INTEROFFICE MEMORANDUM

Ref #: PD-14-09-058

RE : Zinnia Towers (ZNT) - South Tower

Deletion of Parking Slots

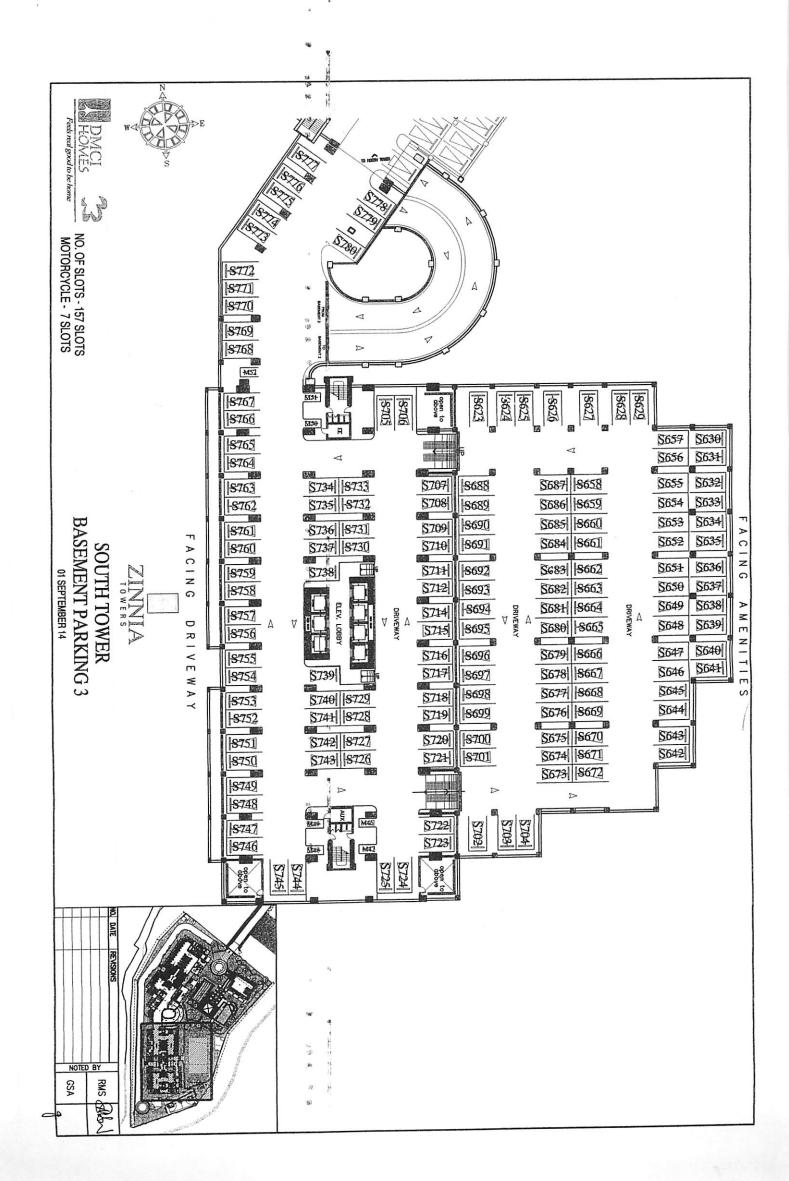
Deletion			
SOU PS 287	SOU PS M26		
SOU PS 286	SOU PS M27		
. SOU PS 285	SOU PS M33		
SOU PS 284	SOU PS M34		
SOU PS-283			
SOU PS 282 *			
SOU PS 281			
SOU PS 280			
Total: 8 Parking Slots	Total: 4 Motorcycle Parking Slots

Revisions were made due to the addition of Al Fresco and commercial space at ground floor area.
